CNSC Commission Member Document (CMD)

CMD 22-H8.1A

SRB Technologies (Canada) Inc.

Request for Renewal of Nuclear Substance Processing Facility Operating Licence

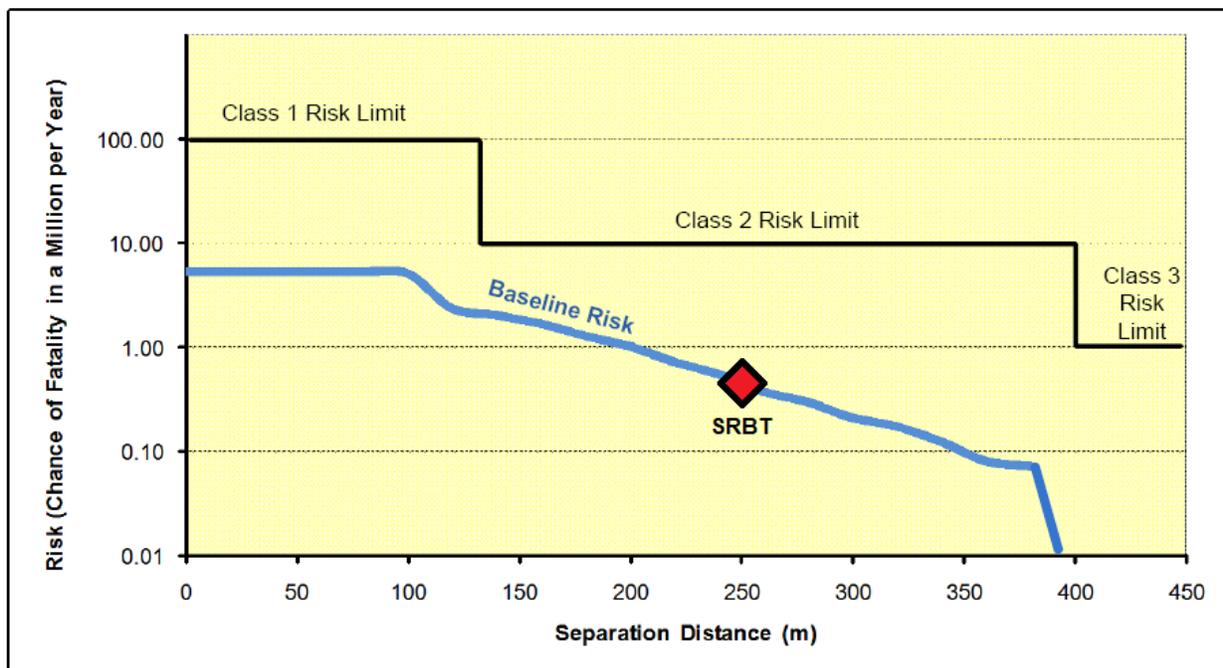
In section 3 of CMD 22-H8.14, the author provides several technical comments on the potential impact of an accident scenario at a propane transfer facility near SRBT.

The author of CMD 22-H8.14 also suggests that additional deterministic consequence analysis be integrated into the SRBT SAR in order to predict the consequences of a BLEVE on the facility. In the event such a low-probability event were to take place, the SRBT facility could indeed potentially be impacted by blast wave overpressure, thermal radiation from a fireball, and missile impact.

Combining the hazard frequencies, the probability of fatality, and the distances and characteristics of the land usage surrounding the transfer facility, a risk summary curve is generated that leads to the conclusion that the risk is below the MIACC Risk Assessment Criteria risk limits, and no additional mitigation is required on behalf of the facility operator.

The risk summary curve is presented here, including a highlighted point on the curve showing the distance at which the SRBT facility is located.

The SRBT SAR states that *“any interaction between the physical effect of the worst-case accident and nuclear substances in the facility is expected to be bounded by the analysed worst-case scenarios for the SRBT facility alone, from the point of view of radiological hazards to workers, the environment and the public”*.

Nonetheless, the author's points are acknowledged and appreciated, in that the facility safety analysis could be improved to include more detail in these areas. SRBT will certainly take these points into consideration during the next review and revision cycle for the SRBT SAR, scheduled for November 2022.
